SUMMARY OF RESPONSES TO USEPA's CONDITIONAL APPROVALS AND COMPLETION REPORTS INFORMATION
LETTERS DATED JULY 2, 2010, JULY 1, 2011 and FEBRUARY 4, 2011 ON THE POLYCHLORINATED BIPHENYLS NOTIFICATION PLAN
Former Pechiney Cast Plate, Inc. Facility
3200 Fruitland Avenue
Vernon, California

APPENDIX A

APPENDIX B

SITE RECORD PLAN
Former Pechiney Cast Plate, Inc. Facility
3200 Fruitland Avenue
Vernon, California

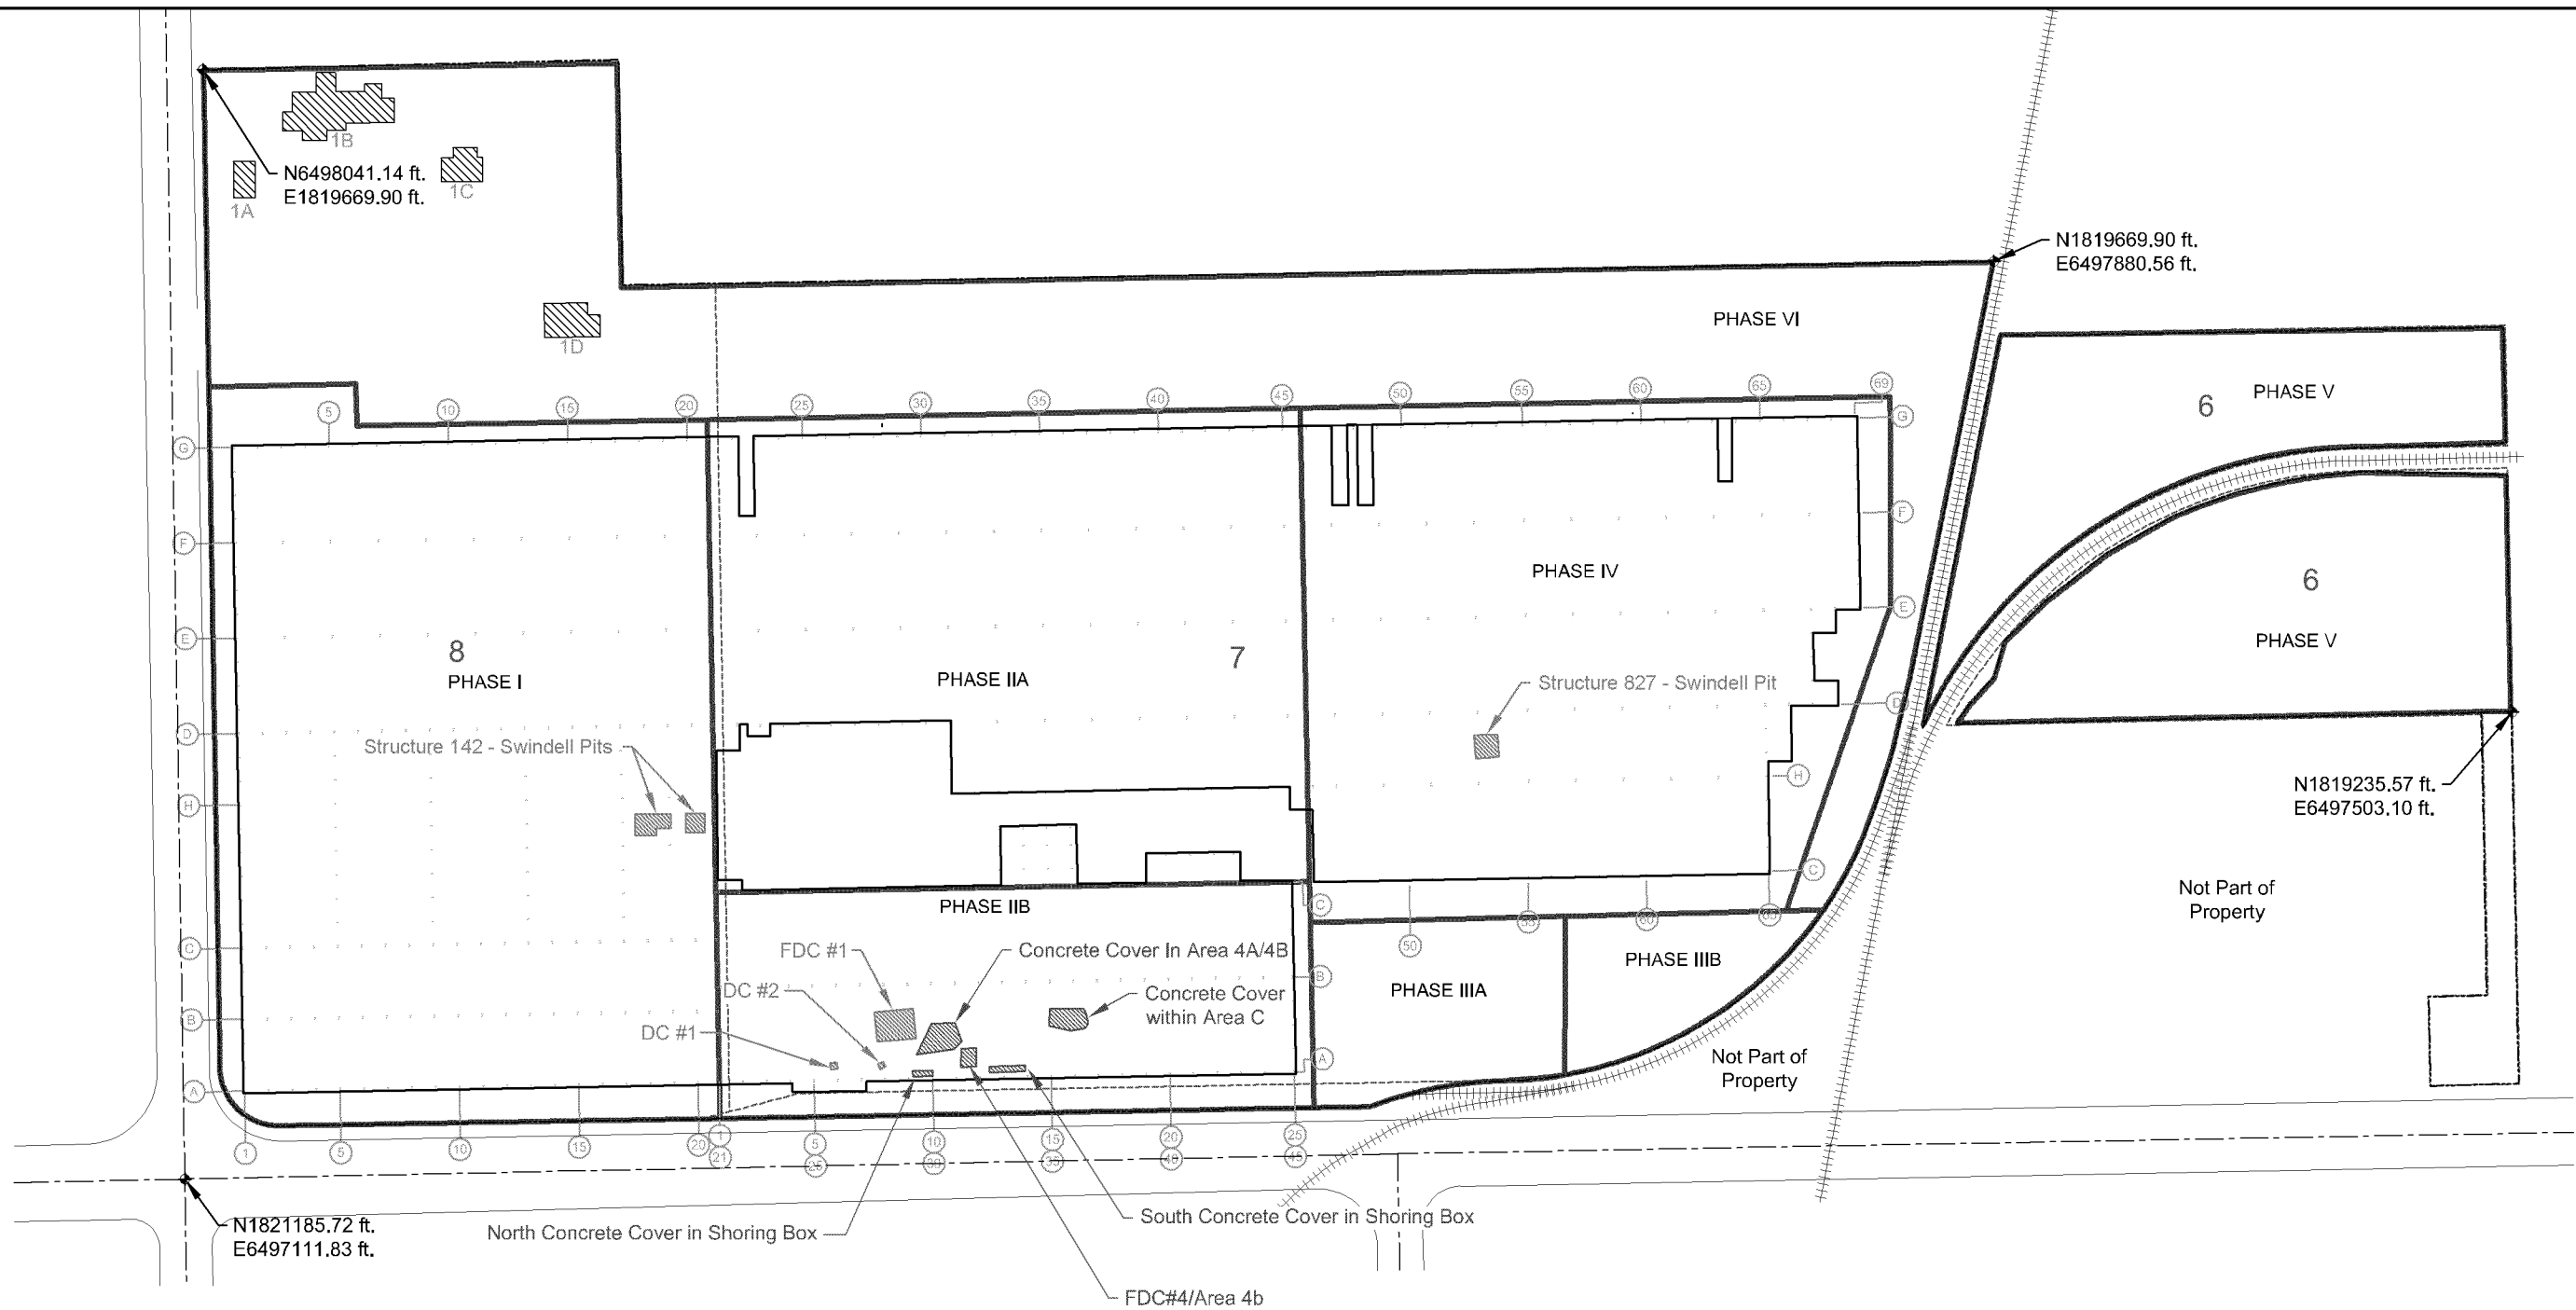
| REFERENCE | CONDITION | COMPLETION REPORT SECTION | RESPONSE/INFORMATION |
|--|--|--|---|
| July 2, 2010 | C.7.h. Figure 9, PCB Soil Remediation Areas, Former Pechiney Cast Plate Inc., Facility dated 07/01/2009. | Not applicable | <p>The available PCB concentrations associated with structures 1A (3.6 mg/kg of total PCBs), 1B (unknown), and 1C (2.0 mg/kg of total PCBs) were posted on the grading plan submitted to USEPA on July 15, 2011. These structures were left in place by Alcoa and covered with 8 inches of concrete. These three structures remain in place at an elevation of approximately 169 feet mean sea level, which is approximately 14 to 16 feet below the parking lot pavement in the northeastern portion of the site. The fourth structure ("Homo Furnace Pit") is a concrete slab and remains in place at elevation of approximately 170.5 feet mean sea level.</p> <p>The location and presence of these structures will be documented in the Land Use Covenant and shall not be disturbed during future site grading and redevelopment. As noted earlier, the Record Drawing for these older structures and the structures cut and capped in placed during the below grade demolition work is shown on the Record Drawing provided in Appendix B of this summary.</p> |

| REFERENCE | CONDITION | COMPLETION REPORT SECTION | RESPONSE/INFORMATION |
|-----------|---|--|--|
| | <p>(e) A survey is conducted to (1) final excavation floor and UWB; (2) total PCB and Aroclor concentration below the UWB....</p> <p>(f) Restricted land use covenant.....</p> <p><u>Additional Requirements</u>....The UWB shall be constructed with concrete or cement slurry pr other suitable materials that allows a completion thickness of 6 inches.....The UWB shall be overlain by a colored (e.g. orange) mesh geotextile layer</p> | <p><u>Phase II</u> Tables 7 and 8</p> | <p>(d) Soil samples were collected for the analysis of volatile organic compounds (VOCs; EPA 8260) and petroleum hydrocarbons (TPH; EPA 8015M) in Area 4a/4b and Area C from soil associated with the UWB. These soil samples included:</p> <p><u>Area 4a/4b (under the UWB):</u> #1074, #1075, #1076, #1077, #1079, #1081</p> <p>For these samples, VOCs were not detected. Petroleum hydrocarbons in the diesel range (not detected to 1,210 mg/kg) and heavy oil range (not detected to 2,520 mg/kg) were detected in the soil samples, and are likely associated with the former hydraulic oils that contained PCBs.</p> <p><u>Inside the Shoring Area for 4a/4b</u> (sample were collected throughout the shoring area): #951, #951-24, #953; #954; #954-22; #955; #956; #958, #960-22; #961; #961-22; and 967-24.</p> <p>For these samples, VOCs were not detected. Petroleum hydrocarbons in the diesel range (not detected to 124 mg/kg) and heavy oil range (not detected to 115.6 mg/kg) were detected in the soil samples, and are likely associated with the former hydraulic oils that contained PCBs.</p> <p><u>Area C (under the UWB):</u> #854 and #855</p> <p>For these samples, VOCs were not detected with the exception of the trace detection of benzene at 1.1 µg/kg (#854). Petroleum hydrocarbons in the diesel range (not detected and 329 mg/kg) and heavy oil range (not detected and 4,897 mg/kg) were detected in the soil samples, and are likely associated with the former hydraulic oils that contained PCBs.</p> <p>In addition, the areas with the UWB are not co-located in the areas with known Stoddard solvent-impacted soil (Phase III/IV Area) or volatile organic compound-impacted soil (Phase I Area).</p> |

| REFERENCE | CONDITION | COMPLETION REPORT SECTION | RESPONSE/INFORMATION |
|-----------|---|--|--|
| | | <p><u>Phase II</u> Appendix F (Concrete Cover within Area C; FDC #4; North Concrete Cover in Shoring Box; Concrete Cover in Area 4A/4B; South Concrete Cover in Shoring Box)</p> | <p>(e) A summary of the survey data for the areas with the UWB is provided on the site-wide Record Drawing attached (Appendix B of this summary). In additions, this information is included in the Completion reports.</p> <p>The UWB was constructed with a minimum of 6-inches of concrete that was covered with an orange mesh geotextile layer.</p> |
